DRY CREEK MITIGATION PLAN

Durham County, NC NCDEQ Contract No. 6827 DMS ID No. 97082

Re: NCIRT Review and USACE Approval of the Dry Creek Mitigation Plan; SAW-2016-00880; NCEEP Project # 97082

Subject: Final Mitigation Plan

Figure 6 Existing Conditions Map Dry Creek Mitigation Site New River Basin (03020201)

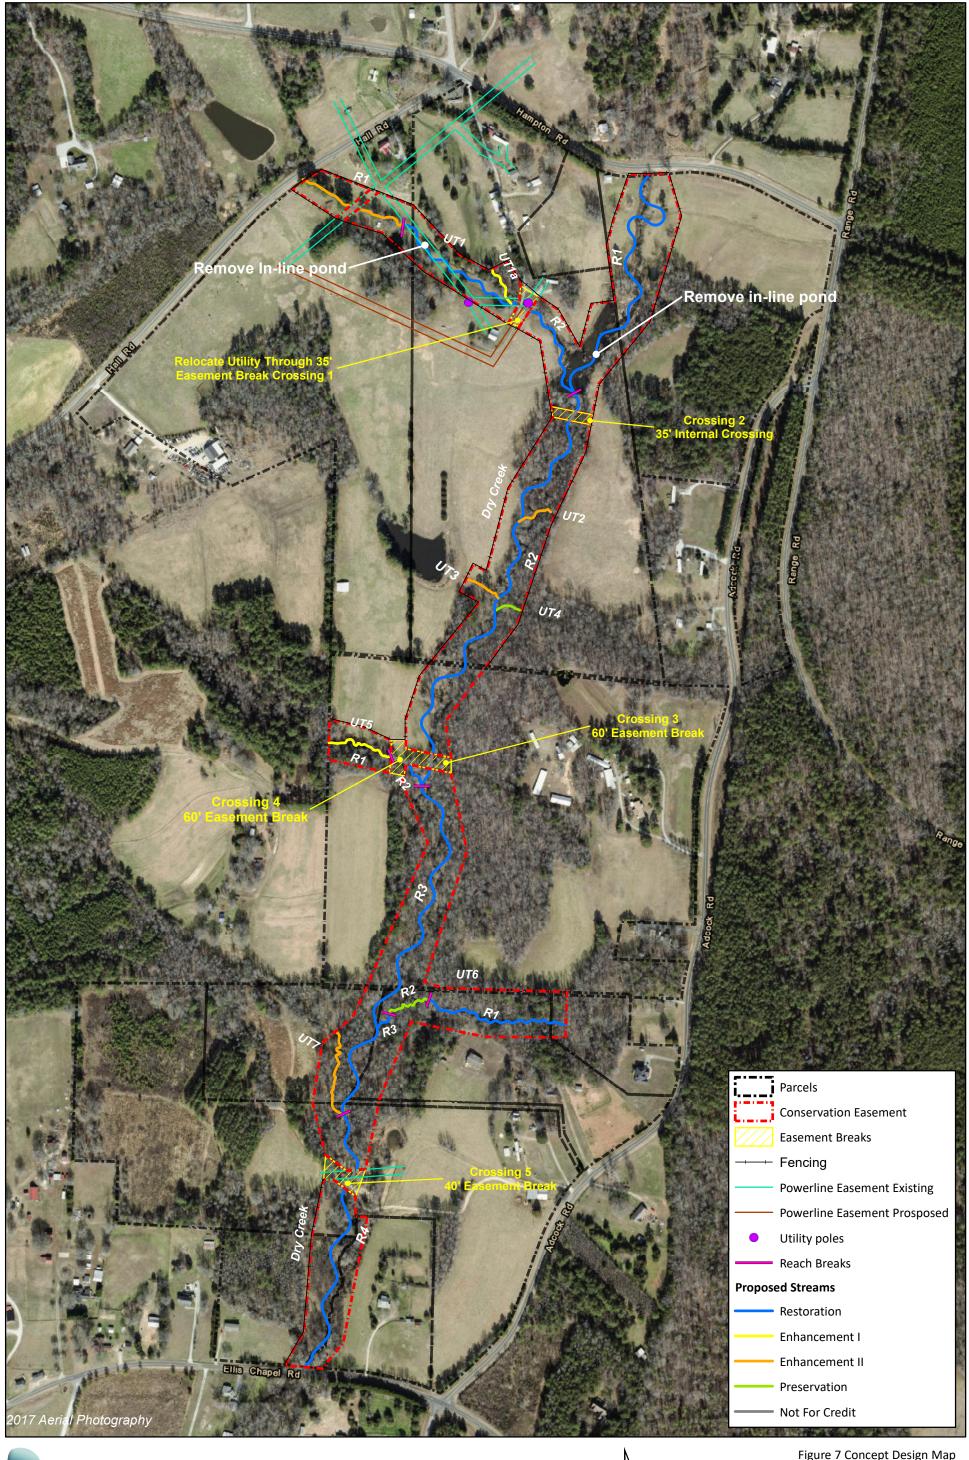
1. Dry Creek – Reach 3 is shown above the confluence with UT5 in Figure 6.

This has been corrected on the figure.

h h Figure 7 Concept Design Map Dry Creek Mitigation Site New River Basin 03020201

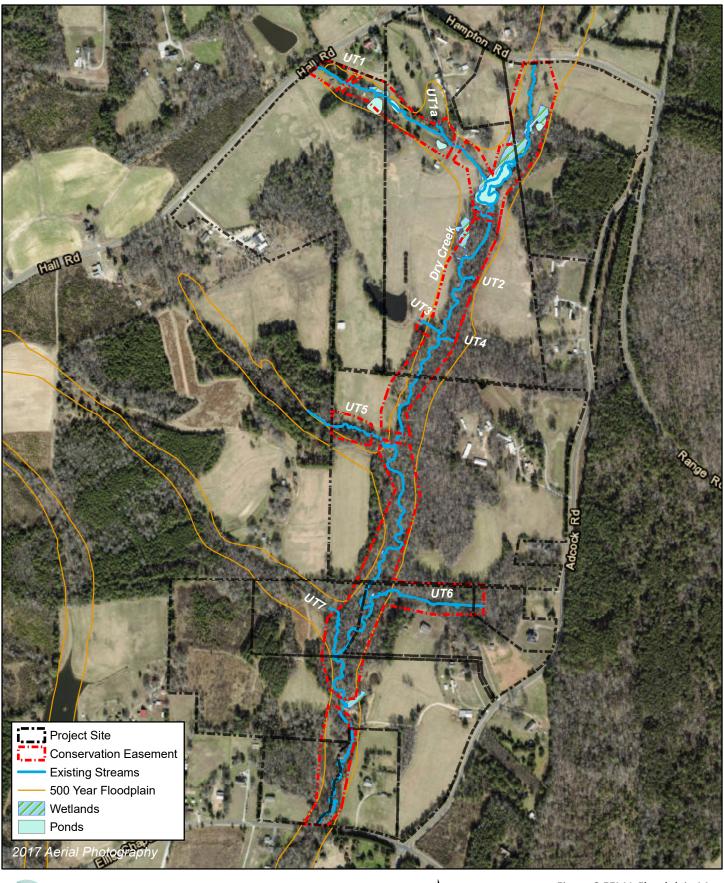
5. The site description of constraints should be corrected to one internal easement crossing and four external crossings per Table 9 and Figure 7 Concept Design Map.
